1984 - 1985 Corvette: Service Bulletin: Door Ajar Switch Corrosion

Source: Chevrolet Dealer Service Bulletin

Bulletin Number: 85-43, Number 8B (XII) & 10(I)

- REPLACEMENT 14087681 DOOR AJAR SWITCH
(WITH SLEEVE)

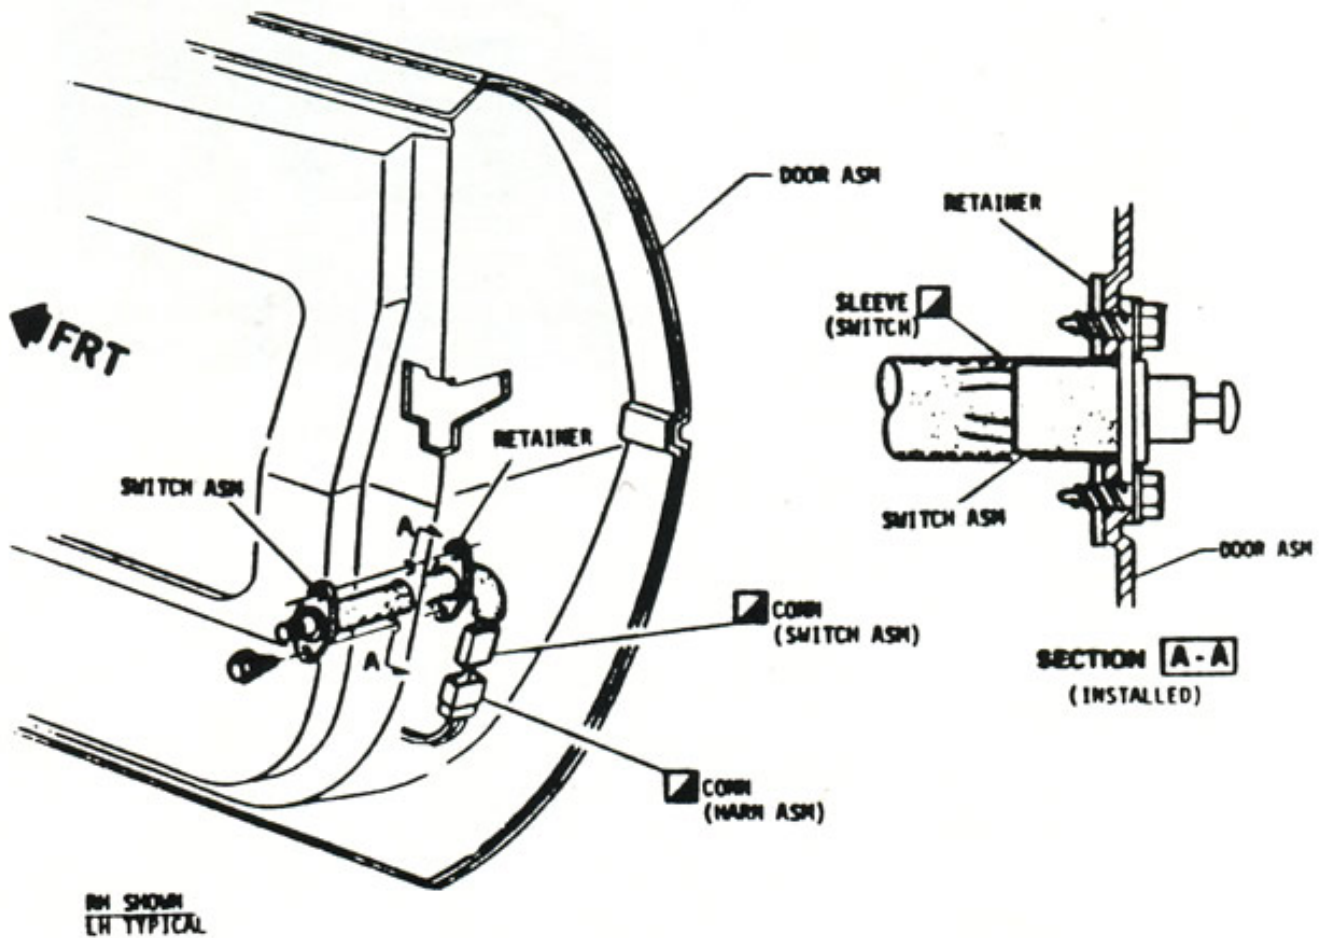
SOME 1984 AND EARLY PRODUCTION 1985 CORVETTE DOOR AJAR SWITCHES (P/N 14062556) MAY BECOME INOPERATIVE DUE TO INTERNAL CORROSION. THIS CAUSES THE DOOR AJAR LIGHT TO EITHER BECOME INOPERATIVE, FLICKER, OR STAY ON.

A NEW CORROSION RESISTANT SWITCH (P/N 14087681) AND AN ASSOCIATED RETAINER (P/N 14087682) ARE TO BE USED AS SERVICE REPLACEMENTS. THE NEW SWITCH INCLUDES A SLEEVE (SEE ILLUSTRATION) THAT FITS TIGHTLY AROUND THE SWITCH'S HOUSING AND HAS SUFFICIENT LENGTH TO COVER THE WIRE CONNECTOR ONCE CONNECTION TO THE DOOR HARNESS IS MADE.

WHEN REPLACING THE EXISTING SWITCH WITH A NEW 14087681 SWITCH, THE DOOR INSERT HOLE WILL NEED TO BE ENLARGED FROM 16MM TO 18MM TO ACCOMMODATE THE SLEEVE PROVISION. CARE MUST BE EXERCISED WHEN ENLARGING THE INSERT HOLE SO THAT ADJOINING MOUNTING HOLES ARE NOT ALTERED. SCRATCHES, CHIPS, ETC., TO DOOR PANEL SURFACE RESULTING FROM THE HOLE ENLARGING PROCESS ARE TO BE COSMETICALLY REPAIRED AS OUTLINED IN SECTION 10 (BODY) OF THE CORVETTE SHOP MANUAL.
